11 September 2026

Minor Change to Development Approval at 25 Harcourt Street, New Farm (Council Ref: A006752507)

Figure 2 – Comparison of Level 1 Floorplans

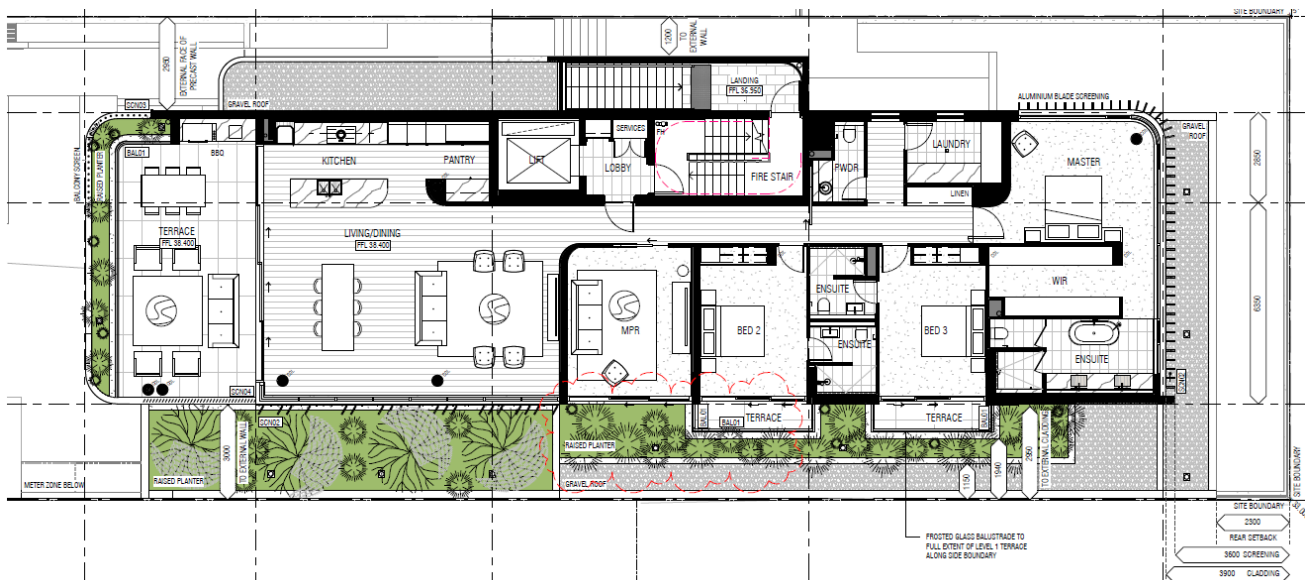
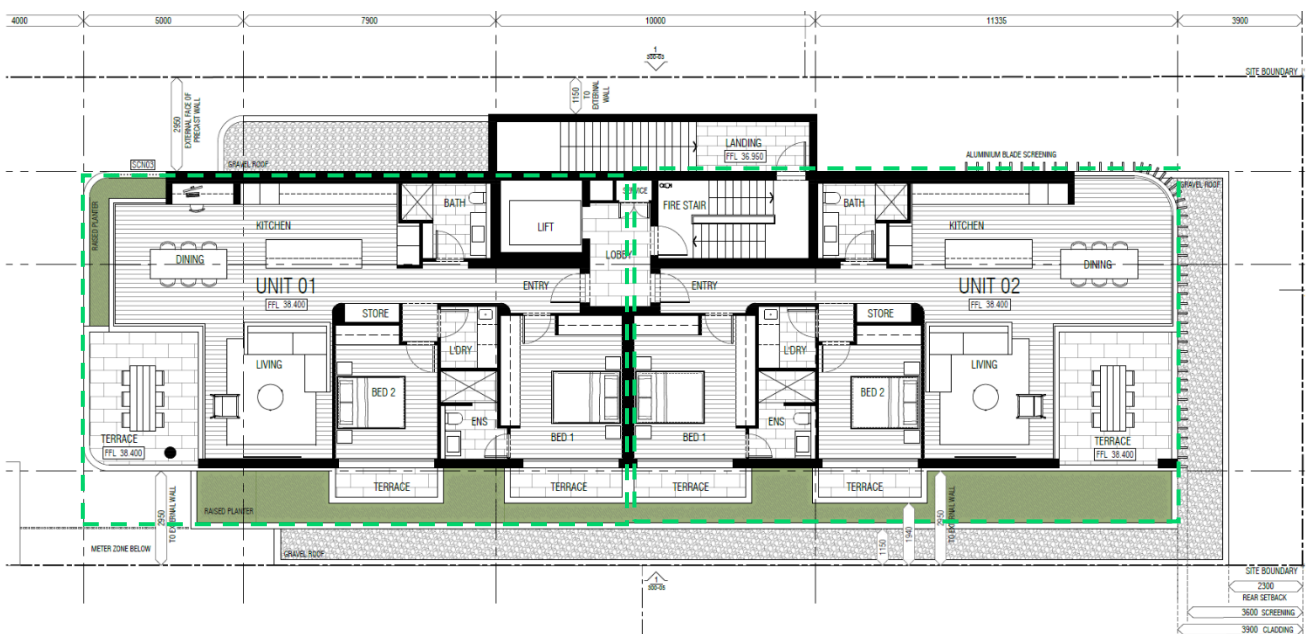
The internal layout of Level 1 has been revised to facilitate the addition of a second apartment unit within the approved floorplate. As illustrated in **Figure 2**, the revised design provides for two (2) separate two-bedroom apartments, arranged on either side of the lift core. The revised layout of Level 1 provides a greater variety in the product mix, enhancing housing choice and diversity for the locality and broader city.

Further to the revised internal layout on Level 1, the proposed development continues to provide compliant private open space and balcony requirements as per the Multiple Dwelling Code (refer to **Figure 2**). Each Level 1 apartment provides a dedicated primary balcony area that exceeds the minimum 12m² area and 3 metres dimension requirements. To supplement the primary balconies, each unit is provided with Juliette balconies that are accessed from each individual bedrooms. As such, the revised development scheme ensures a similar level of residential amenity and functionality of the dwellings are maintained for future residents.

Figure 3 – Comparison of Levels 4 and 5 Floorplans

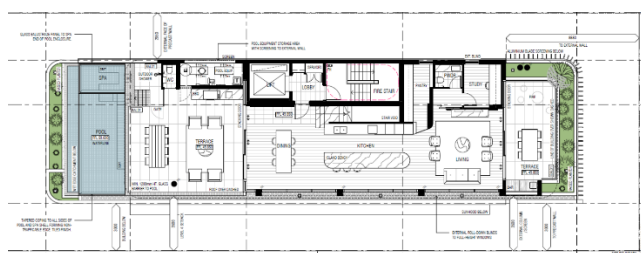
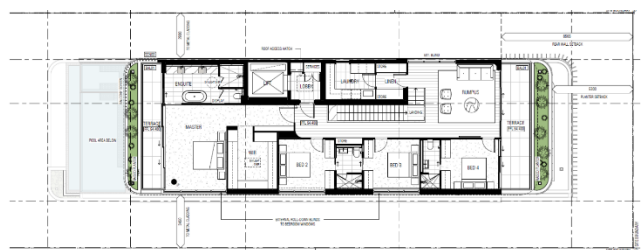
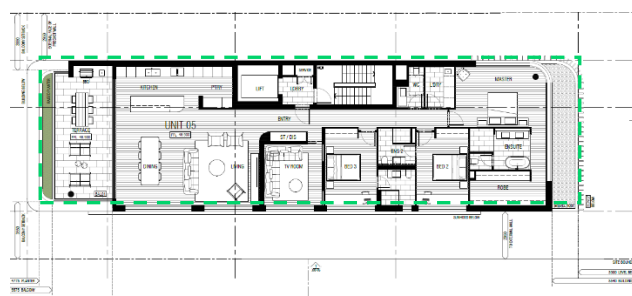
Additional changes are proposed to the layout of Levels 4 and 5, which involve the conversion of the previously approved double-storey penthouse into two (2) separate three-bedroom apartments across Level 4 and 5 (one unit per level) (refer to **Figure 3**).

The revised design of these levels adopts an apartment layout that replicates the internal unit layouts on Levels 2 and 3. Additionally, the revised unit design and removal of the pool at Level 4 allows for a reduction in the overall floor-to-floor height between Levels 4 and 5, which is further discussed in **Section 3.2** and **Table 3** below. When coupled with the generous landscaping and architectural screening elements, the proposal continues to minimise amenity and privacy impacts, and softens the overall bulk and scale of the development.

Figure 4 - Comparison of Roof Level Floorplans

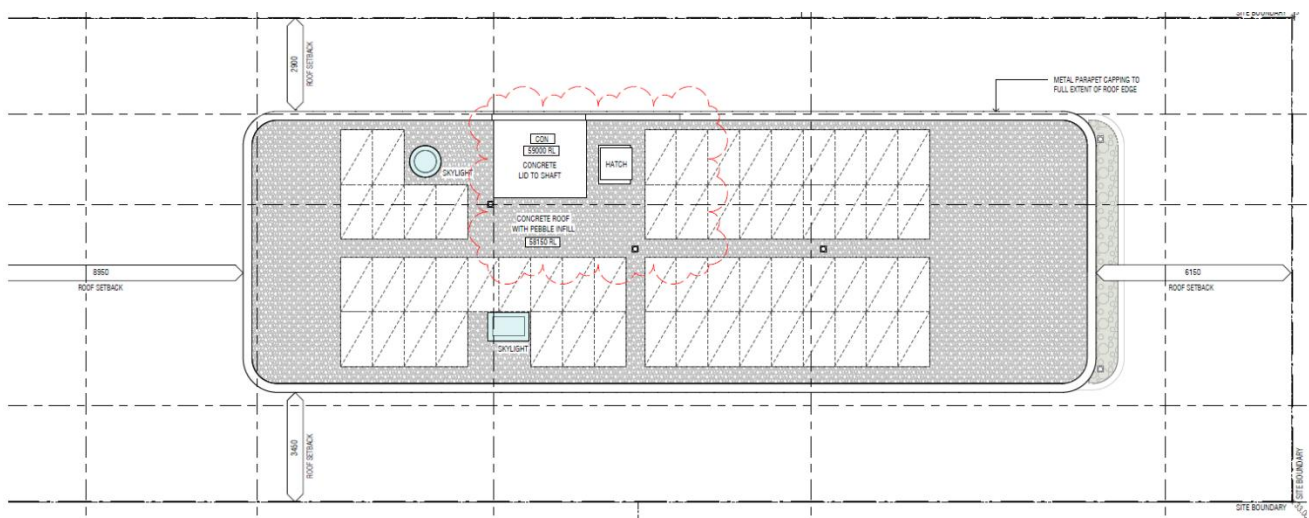
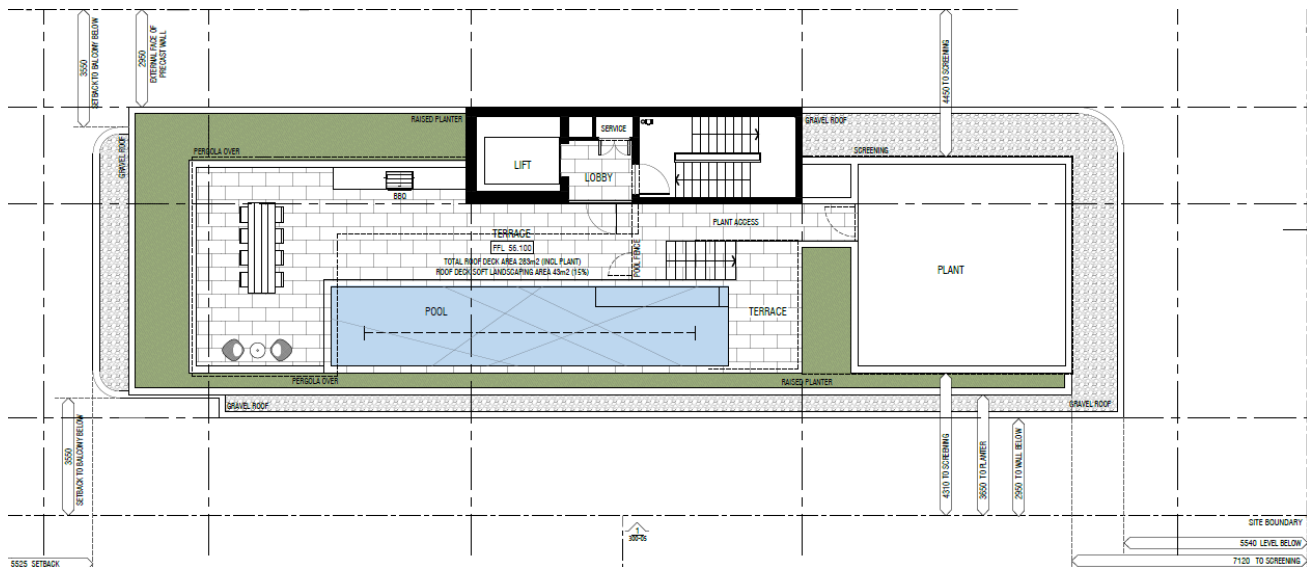
Changes are proposed to the rooftop layout, which seeks to convert the previous unusable rooftop area into a communal rooftop for enjoyment by all future residents (refer to **Figure 4**). The proposed communal rooftop is designed to comply with the provisions of the 'rooftop garden' under the City Plan and thus does not constitute a technical storey. Therefore, the development remains at 6 storeys and does not significantly alter the overall scale or height of the development.

As shown in **Picture 8**, the proposed communal rooftop design includes lift and stair access, a swimming pool and deck, BBQ and dining areas, and shade structures. The range of facilities provided at the rooftop encourages social interaction, relaxation and resident wellbeing. The proposal consolidates mechanical plant towards the rear of the rooftop, which is appropriately screened to minimise visual impacts to the communal open space and from public vantage points.

The proposed rooftop garden incorporates subtropical landscaping around the perimeter, enhancing visual amenity and contributing to shaded and comfortable outdoor spaces. When coupled with the generous private open space delivered across each residential unit, the development provides a high level of amenity and supports the liveability of future residents. Of note, the provision of the communal rooftop represents an improvement to the recreational offering of the development, which in its current approved form does not provide any communal open space for residents.

Figure 5 – Comparison of Approved and Revised Section

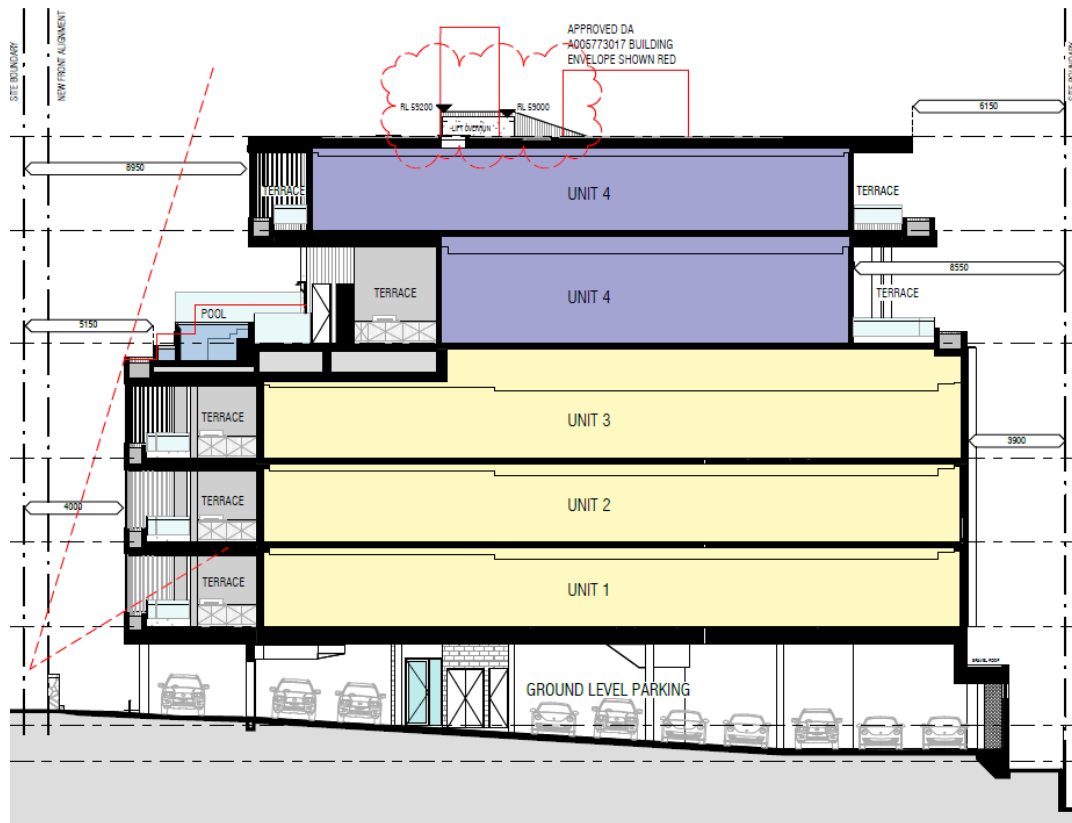
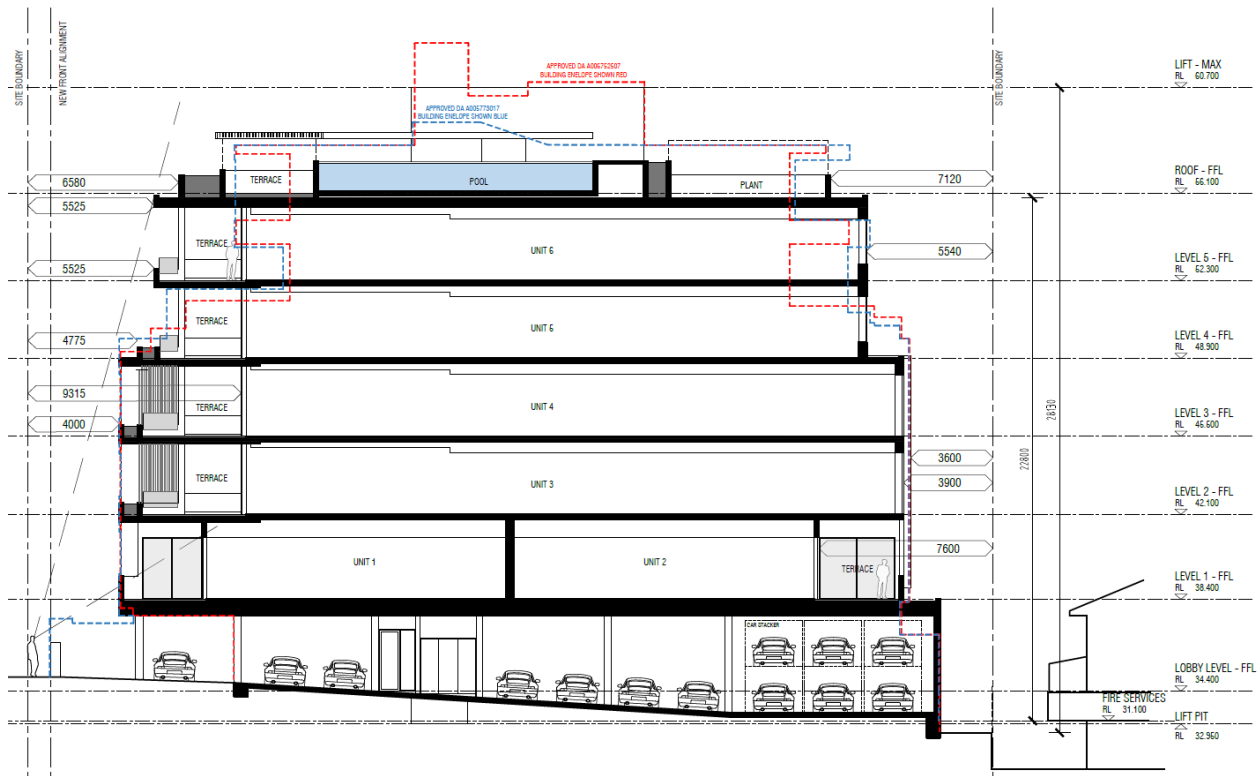
Whilst the number of storeys remains unchanged, the proposed rooftop garden has resulted in subsequent design amendments to the lift overrun arrangements, resulting in a minor increase to the overall maximum height from RL 59.2m to RL 60.5m when measured to the top of the lift overrun. Notwithstanding the

In response to the design changes to the lifts, the floor-to-floor heights of Levels 1, 3, 4 and 5 have been amended as detailed in **Table 3** and shown in **Figure 5**.

Figure 7 – Comparison of Approved and Revised Front Setback at Level 1 (Emphasis Outlined in Green)

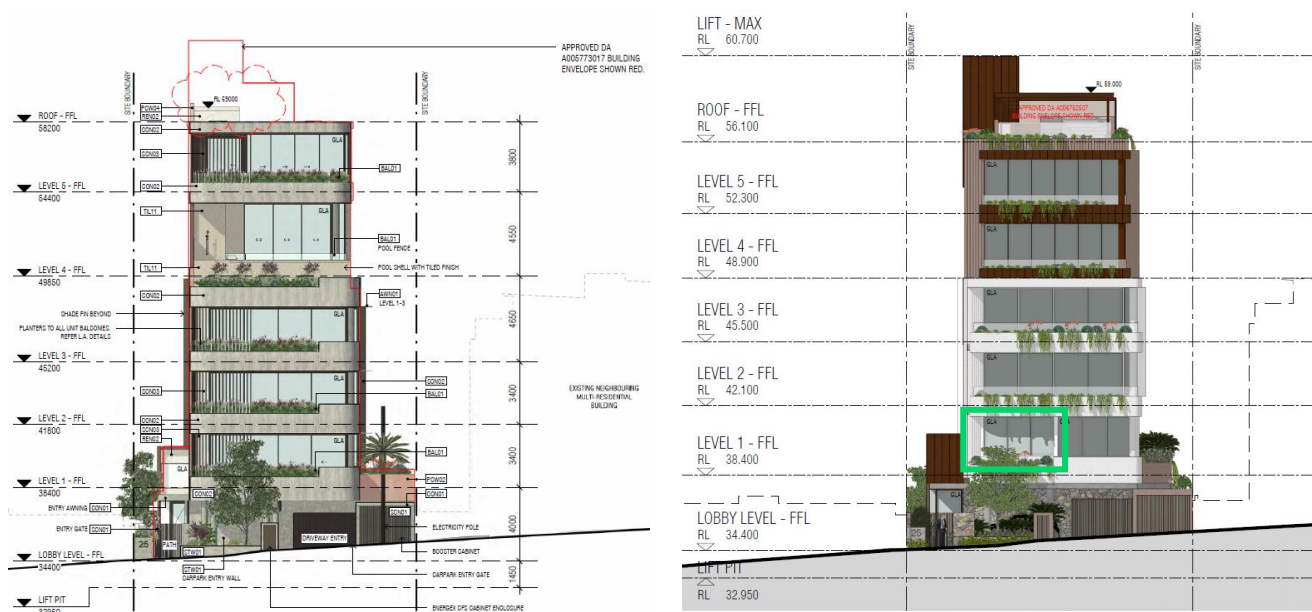
The front and rear setbacks at the lower four (4) levels remain generally consistent with the approved development, with only limited changes proposed to the front setback distances at Levels 1 to 3. At Level 1, while the setback to the building line is reduced from 9.4 metres to 4.6 metres, this reduction applies only to a discrete portion of the frontage. The southernmost portion of the Level 1 frontage continues to comprise a terrace, with the main building line recessed behind, thereby maintaining visual relief and articulation when viewed from the street and adjoining properties (refer to **Figure 7**). In addition, the outermost point of Level 1 remains setback 4 metres to the planter, which is consistent with the approved scheme.

At Levels 2 and 3, the reduction in the front setback from 9.4 metres to 9.3 metres is negligible and would not be readily discernible in the context of the overall building elevation. On this basis, the proposed setback changes do not materially alter the approved built form, presentation or relationship to adjoining development. The approved screening elements remain appropriately located and continue to adequately mitigate oblique views to and from adjoining premises, ensuring that the privacy and amenity outcomes contemplated under the existing approval are maintained.

Figure 9 – Comparison of Approved and Revised Car Parking Arrangements

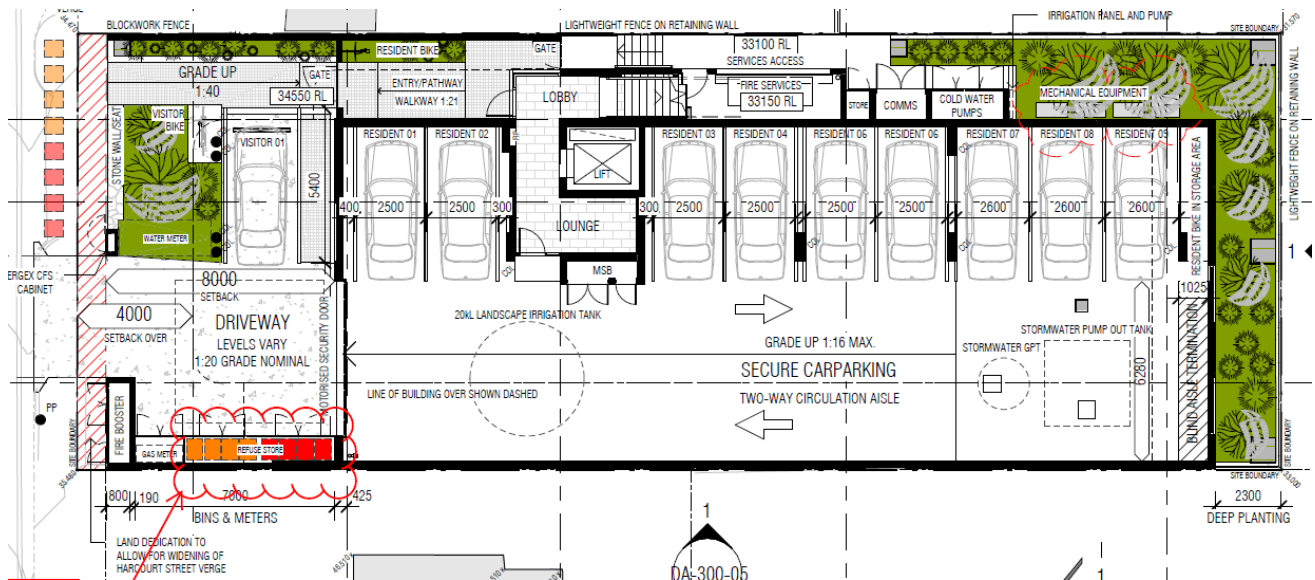
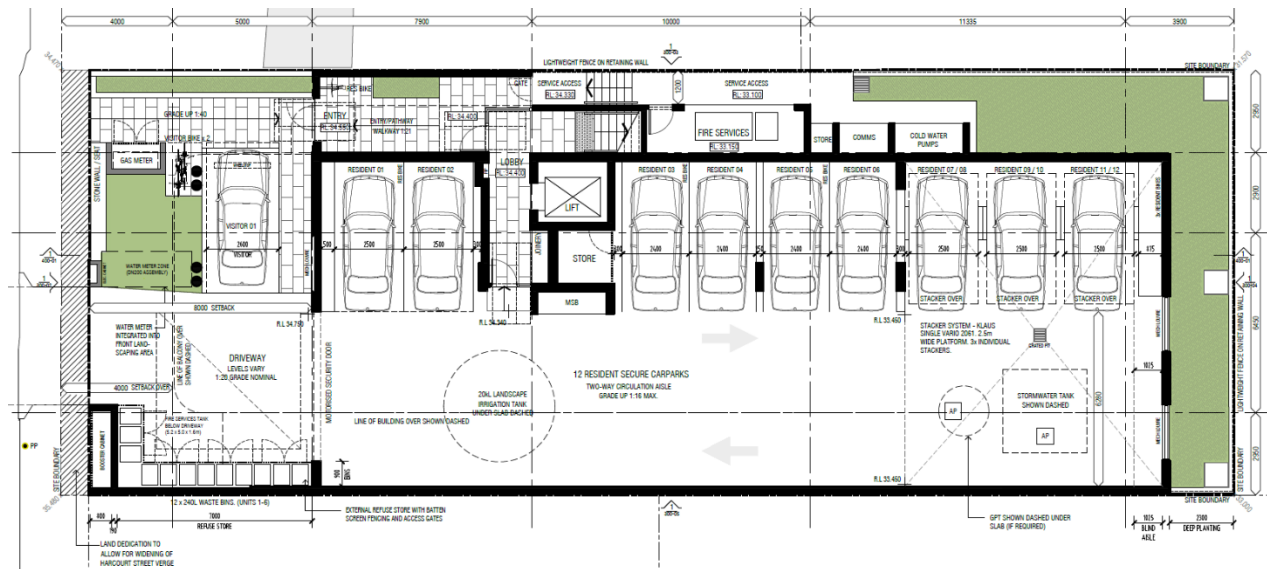
In response to the revised dwelling yield, amendments are proposed to the car parking numbers to facilitate an additional three (3) residential car parking spaces. These additional spaces are accommodated within a car stacker arrangement proposed over the existing three (3) rearmost spaces at the Ground Level (refer to **Figure 9**). Therefore, the provision of the additional spaces is wholly contained within the existing footprint of the Ground Level.

The original application was assessed against version 20 of the City Plan, which identifies the site within the city frame area and is subject to minimum parking rates. Having regard to the requirements under version 20 of the City Plan, the 13 resident spaces comply with the required minimum of 12 spaces.

In relation to visitor parking, the revised scheme requires a minimum of two (2) visitor parking spaces in accordance with the TAPS PSP under version 20 of the City Plan. The proposal retains one (1) visitor space, consistent with the existing approval, which represents a minor shortfall of one (1) space. Notwithstanding, the site is located within proximity to high-frequency public transport services along Brunswick Street, providing convenient access to the site and reducing reliance on private vehicle travel for visitors. Therefore, the provision of one visitor parking space is considered acceptable in this instance, having regard to the minor nature of the shortfall, the site's inner-city location, and the availability of alternative transport options within walking distance of the site.

Figure 10 – Comparison of Ground Level Floorplans

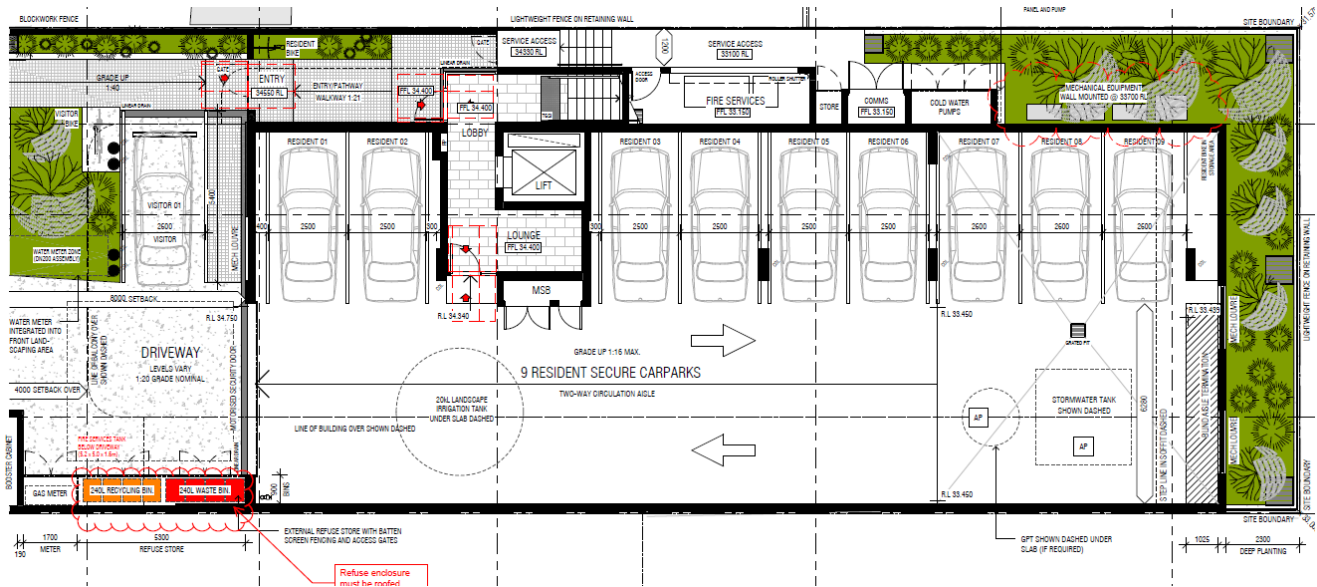
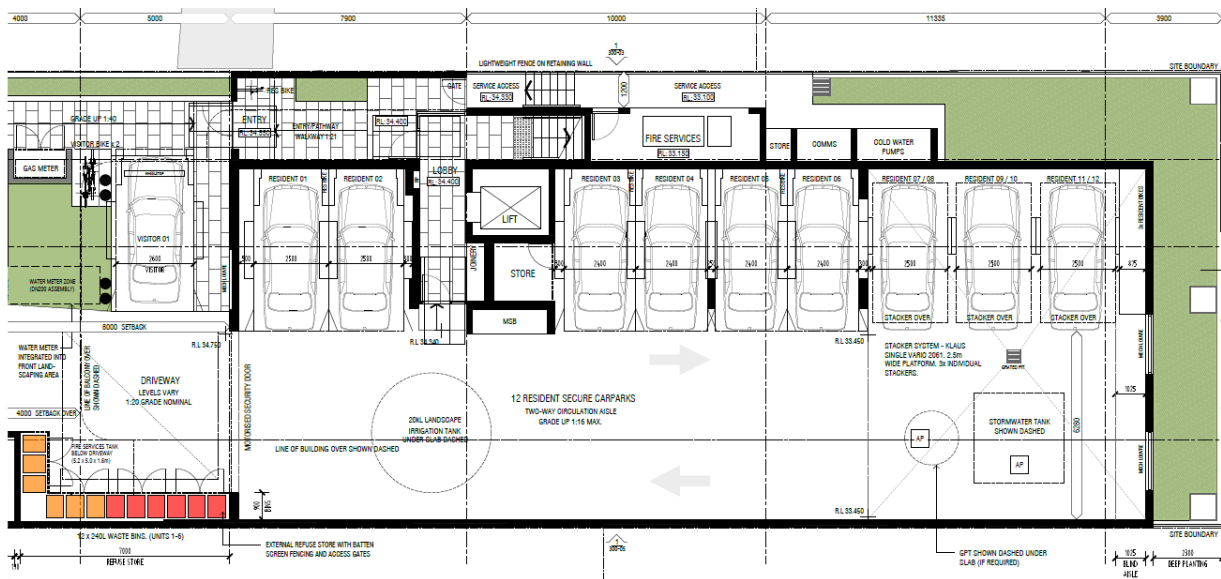
- Rearrangement of the bin storage area along the south-western corner of the site to appropriately service the revised dwelling yield, which accommodates 12 x 240L waste bins (previously 8 x 240L waste bins);
- Relocation of gas meter infrastructure to the front entry way to accommodate the revised refuse storage arrangements;
- Relocation of airconditioning units from the deep planting area at the north-eastern corner of the Ground Level to the dedicated plant room at the Roof Level;
- Minor amendments to the plant infrastructure on the roof level responding to updated engineering demands from the residential apartments of the development (see **Figure 4**).

It is noted the revised mechanical plant arrangements at the Ground Level results in a minor amendment to the landscaping design, which increases the total extent of unobstructed deep planting area.
